AGENDA
DANIA BEACH CITY COMMISSION
REGULAR MEETING
MONDAY, DECEMBER 11, 2017 - 7:00 PM

- 1. Dania Beach Marina Restroom Renovation Design - Public Services and Cartaya and Associates Architects, P.A.

Sheet
A2.03

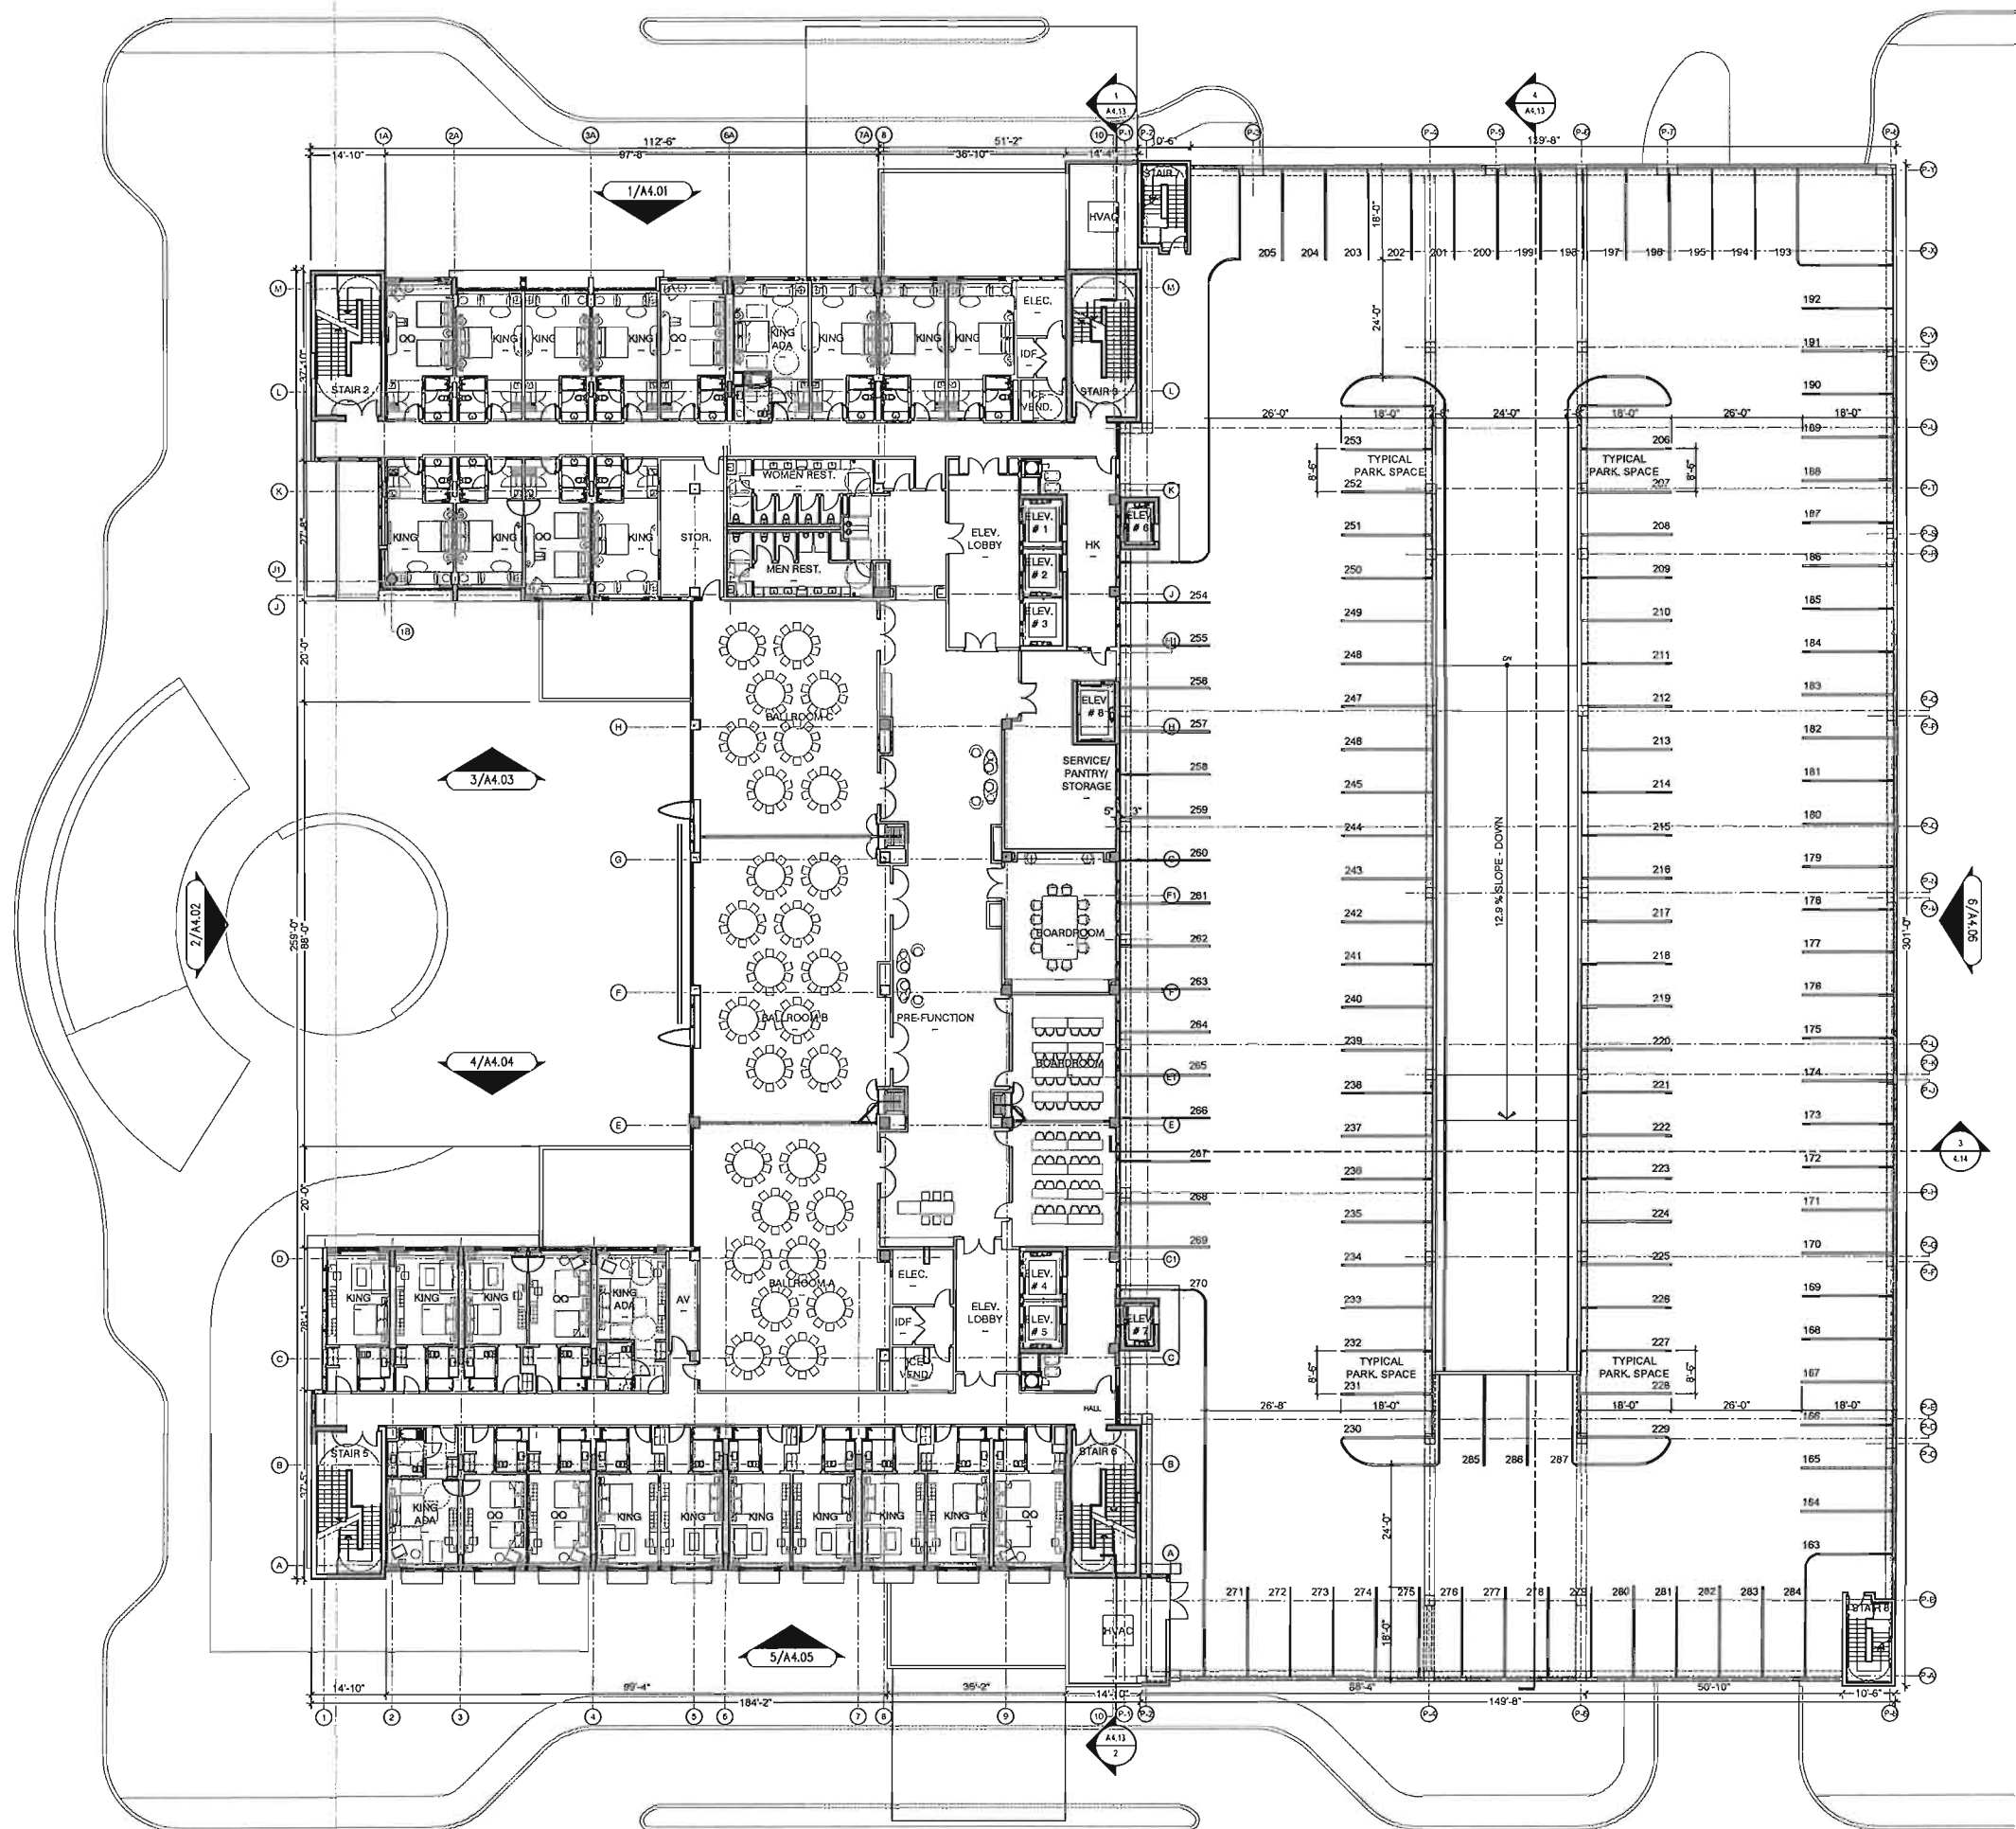
- Sheet A1.02 identifies 292 parking spaces provided, but Sheet A2.03 shows $287 + 8 \text{ ADA} = 295$. Revise accordingly.
 - Provide note on plan that identifies where parking for each use will be located.

Sheet
A4.13

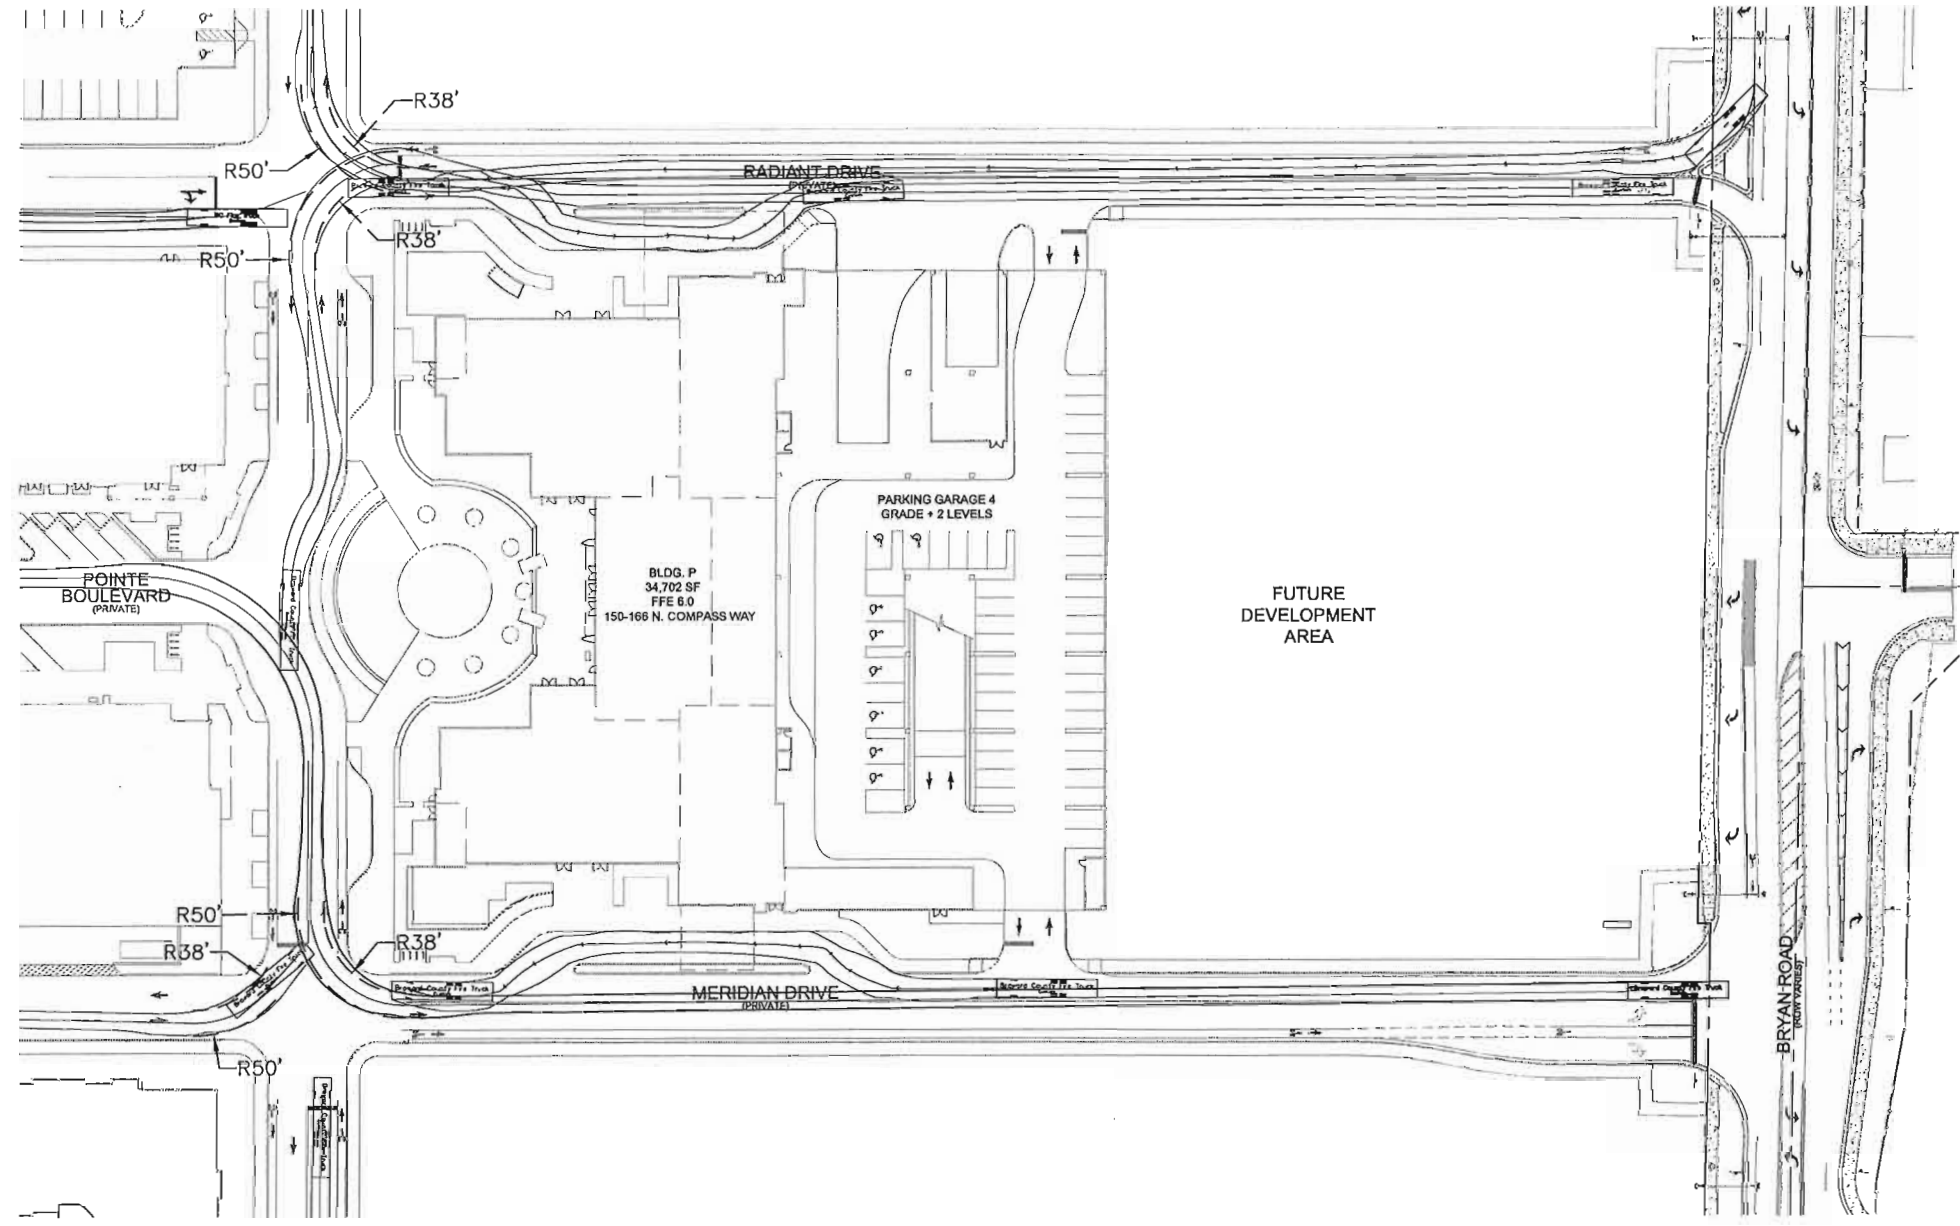
17. Identify where parking garage #4 is located on Sheet C-400A or provide note on Sheet C-400A.
 18. On Sheet A4.13 revisit the transition blend; 9'6" provided run at 6.6%. The dimensions of Parking, 5th Edition, a publication by The Urban Land Institute and the National Parking Association, recommends 12' run (minimum) at 6% grade. Please accommodate this in your design (Engineering).
